ROAD SAFETY AUDIT

Title: **STAGE 1 ROAD SAFETY AUDIT**

**Primary Care Centre & Nursing Home, Moygaddy, Co. Meath.**

Report reference: **1388R02**

Drawing S665- OCSC-1B-MH-DR-C-0111 S2 P01 Sheet 2 of 3, cycle track across side road.

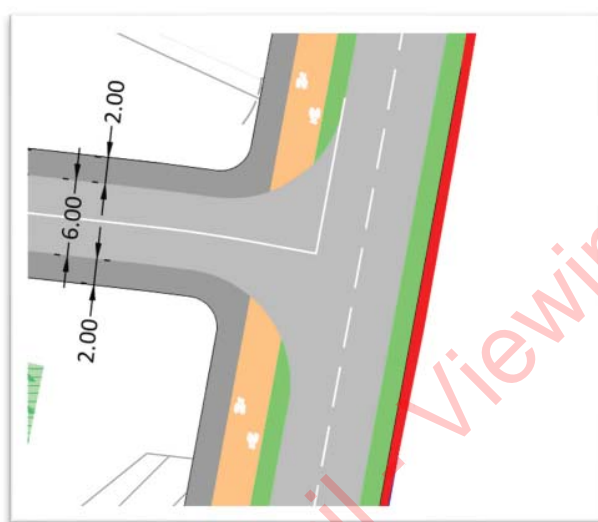
The proposed two way cycle track crosses the mouth of the proposed side road. There is a risk that drivers exiting the side road may not expect two way cyclists as they approach the stop line.

It is recommended that a 'bend out crossing' be provided.

3.2	Y	N	It is proposed to provide a shared space and tactile for crossing before the cyclist and pedestrian approach the junction. A raised crossing will be provided to indicate priority for pedestrians and cyclists.	Yes

Drawing S665- OCSC-1B-MH-DR-C-0111 S2 P01 Sheet 2 of 3, Side road cross section.

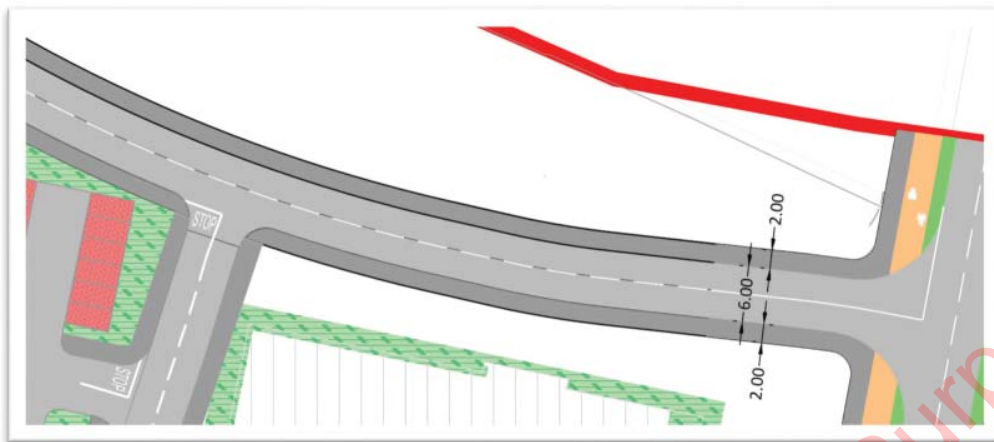
There are no dedicated cycle facilities along the proposed side road. The side road will be a busy area with vehicular traffic when fully developed and this will increase the risk for cyclists.

It is recommended cycle tracks be provided on both sides of the side road.

3.3	Y	N	It is not anticipated to have high volume of pedestrian and cyclist traffic. 2m wide shared use will facilitate pedestrian and cyclist movement	Yes

Drawing S665- OCSC-1B-MH-DR-C-0115 S2 P01 Visibility Splay at side road junction with R157.

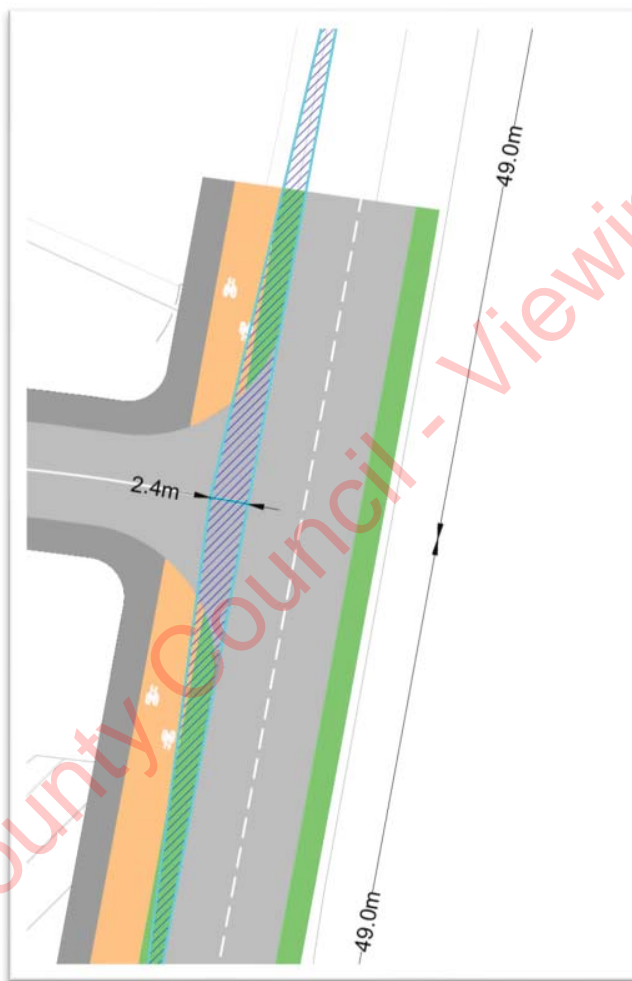
The visibility splay is shown for a 50km/hr urban design speed. The speed limit on the R157 is currently 80km/hr. There may be insufficient visibility to oncoming vehicles leading to side-impact or rear-end collisions.

It is recommended that visibility splays to the posted speed/design speed be provided.

3.6	N	N	The visibility splay is achieved for 50kmph. The new speed limit will be 50kmph once the new distributor road and development is completed.	Yes

Drawing S665- OCSC-1B-MH-DR-C-0112 S2 P01 Sheet 3 of 3, Carton Estate boundary wall.

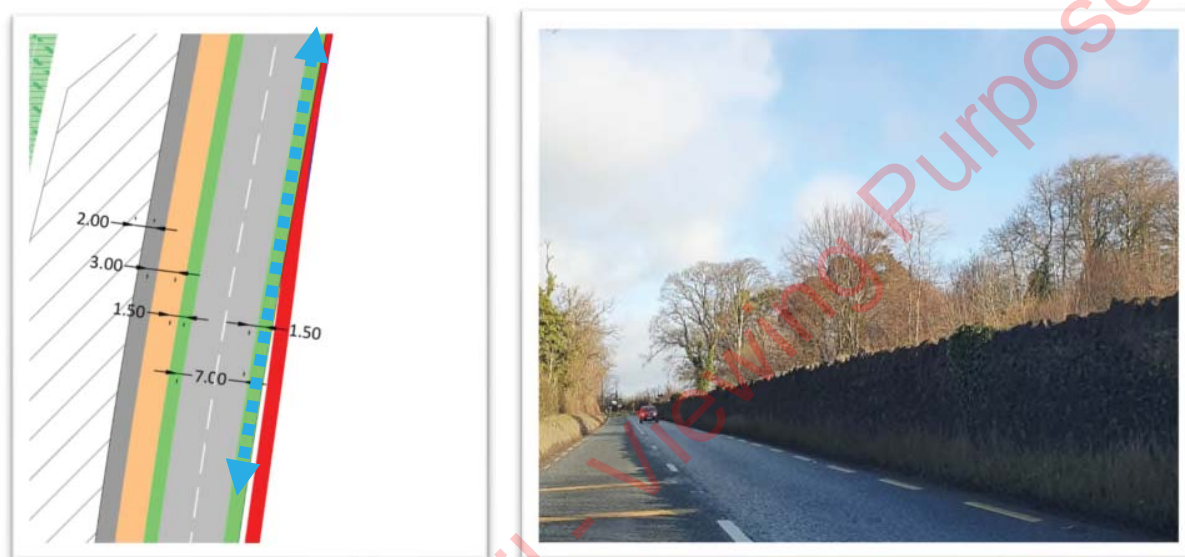
It is proposed to provide a 1.5m verge between the R157 and the Carton Estate boundary wall. The wall may be hazardous if struck by an errant vehicle.

It is recommended that a suitable Clear Zone be provided between the boundary wall and the R157 carriageway.

3.7	N	N	The proposed 1.5 m verge separation is an improvement to the existing condition, and the section of road is straight and the speed limit on the road will be reduced	Yes

once the new distributor road is completed.	
--	--	--	---	--
